Access Compliance Report

Public Rights-of-Way

Intersection ID: 48453	Main Street: ALVARADO_WY	Cross Street: RED_RUST_LN	Location: NW
ADA ID: D3B03F4170E3	Ramp Type: Perp	Initial Pass/Fail: Fail	Overall Compliance: No
		Severity Score: 10

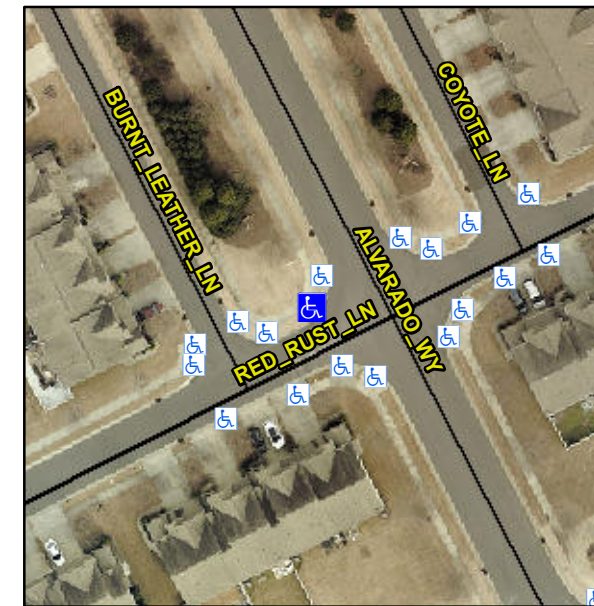
R304.5.1, R304.5.3

Compliance	Description	Data	Compliance	Description	Data
N/A	Ramp Length (in)	133.0	Yes	Ramp Slope (%)	6.2
No	Ramp Width (in)	47.0	No	Ramp XSlope (%)	4.0
N/A	Flare Type LT	N/A	N/A	Flare Type RT	N/A
N/A	Flare Slope LT (%)	N/A	N/A	Flare Slope RT (%)	N/A
N/A	Flare Traversable LT?	N/A	N/A	Flare Traversable RT?	N/A
N/A	Landing Length (in)	N/A	N/A	DWS Provided?	N/A
N/A	Landing Width (in)	N/A	N/A	DWS Contrast?	N/A
N/A	Landing Slope (%)	N/A	N/A	DWS Length (in)	N/A
N/A	Landing X Slope (%)	N/A	N/A	DWS Full Width?	N/A
N/A	Landing Curb? (Y/N)	N/A	N/A	DWS Offset (in)	N/A
N/A	Shared Landing?	N/A			
N/A	Gutter Ponding?	N/A	N/A	Gutter Slope (%)	N/A
N/A	Gutter Lip Ht (in)	N/A	N/A	Gutter X Slope (%)	N/A
N/A	Painted X Walk1?	No	N/A	Painted X Walk2?	N/A
	X Walk 1 Direction	To SE		X Walk 2 Direction	N/A
N/A	X Walk 1 Width (in)	N/A	N/A	X Walk 2 Width (in)	N/A
	X Walk 1 Slope (%)	0.0		X Walk 2 Slope (%)	N/A
	X Walk 1 X Slope (%)	2.8		X Walk 2 X Slope (%)	N/A

Remove & Replace Entire Ramp.
